ON-SITE SEWAGE DISPOSAL SYSTEM HOWARD COUNTY HEALTH DEPARTMENT BUREAU OF ENVIRONMENTAL HEALTH

SUBDIVISION: Daisy Hill Estates LOT NUMBER: 24

SITE PLAN

HERRING RENOVATION/
 ADDITION

OVERALL SITEPLAN

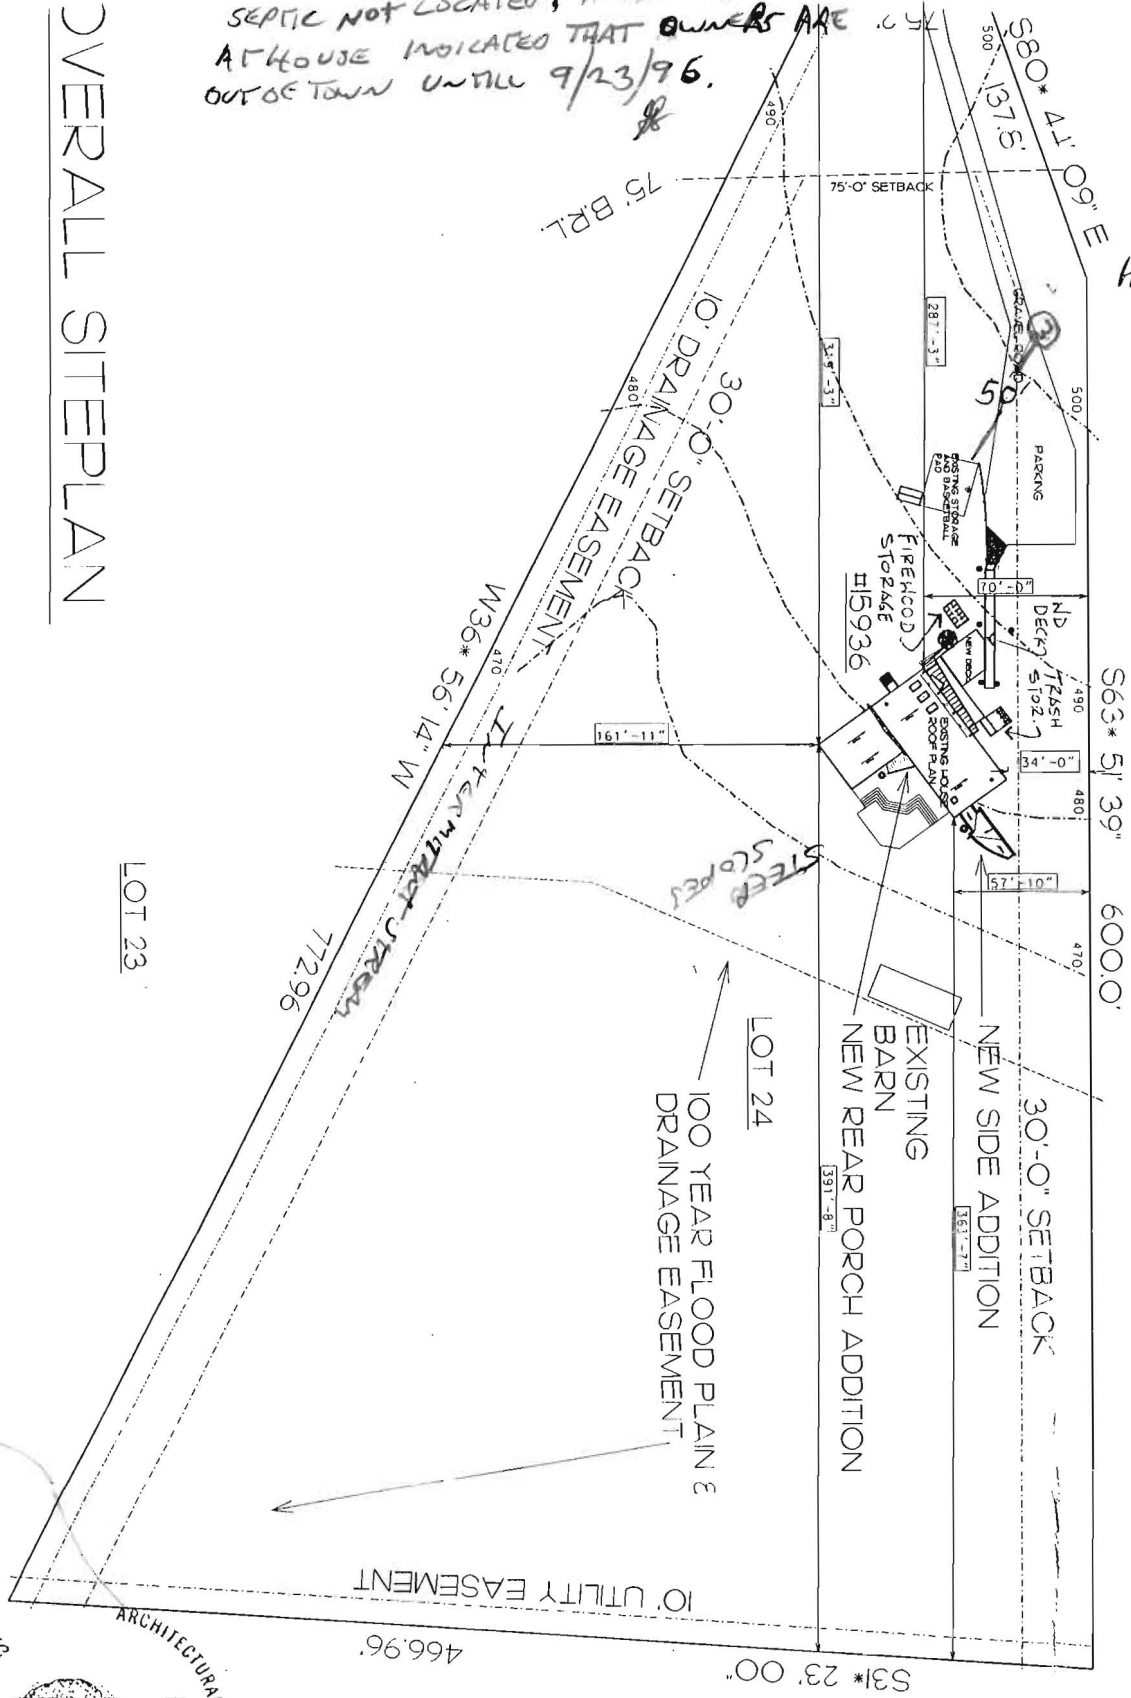
TRENCHES:	Trench to be _____ feet wide. Inlet _____ feet below original grade. Bottom maximum depth _____ feet below original grade. Effective area begins at _____ feet below original grade. _____ feet of stone below distribution pipe.
LOCATION:	
PURPOSE:	In support of building permit. Call for inspection when ground is opened so sanitarian can recommend repair.

9/16/96
 SITE INSPECTION, WELL LOCATED,
 SEPTIC NOT LOCATED, PETSITTER
 AT HOUSE INDICATED THAT OWNERS ARE
 OUT OF TOWN UNTIL 9/23/96.
